DOCUMENT CHANGE REQUEST

DCR number	316	Changes required for:	N/A	Originator:	Olivier Masson Chief
Date:	2007/02/01	Date sent:	2007/02/01	Organisation:	CNES
Status:	IMPLEMENTED

Title: Contacts Power Crimp-Type and Solder Type for 3401/001 and 3401/002 Connectors

Number: 3401/040 Issue: 3

FIGURE 2(c) - PROTRUSION AND RECESS

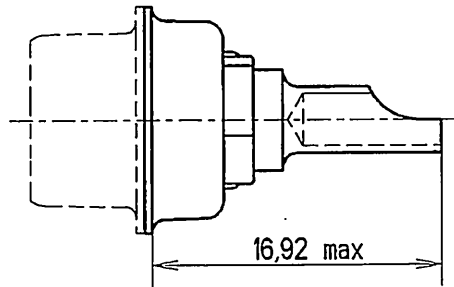
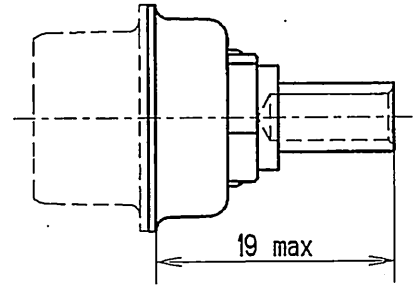
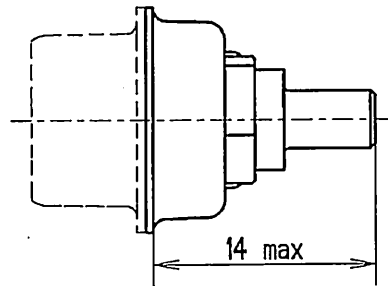
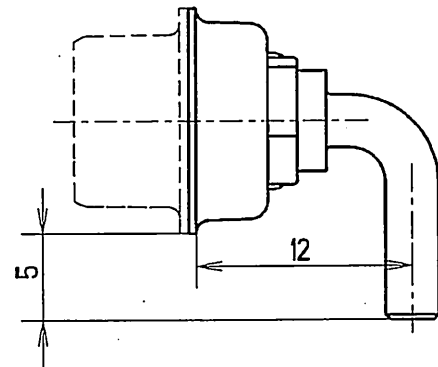
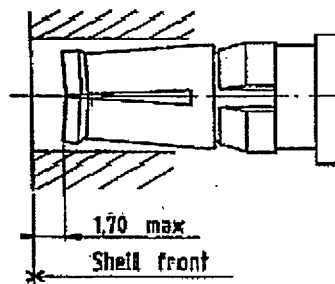
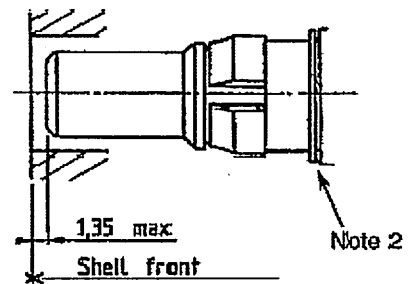
- 1) Page 1, Spec Title: amend to include " ... AND PCB-TYPE FOR ..."
- 2) Page 6 & 11, Para 1.1 & 2. Amend titles of 3401/001 & 3401/002 to reflect the latest titles.
- 3) Page 6, Table 1(a). Manufacturer to advised the maximum weights for new Variants 13 to 16.
- 4) New Figure 2(c). Figure should be in the same format as used in Fig 2(a) & 2(b) i.e. Dimension letter & Table format. Title should be: "FIGURE 2(c) - STRAIGHT AND 90deg PCB TYPE"
- 5) Page 10, Fig 2(c) should be renumbered: "FIGURE 2(d)"
